Product Introduction / Enhancement

M2222 – Locking plate for Zero Reveal Lid Lock

A2895 - Lid Lock Kit for Zero Reveal Flush Lid

A2895 Kit Components

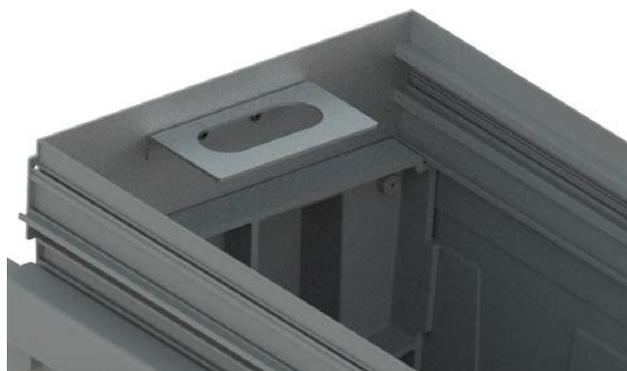
This new plate is designed to work exclusively with the zero reveal lid. It replaces the end support for that style of lid, and includes a slot for the lock to latch into. That prevents the lid locks from slipping away from the end supports in high winds. The new locking plates & mounting fasteners will be included in kit A2895. Pricing will be updated to reflect these added parts.
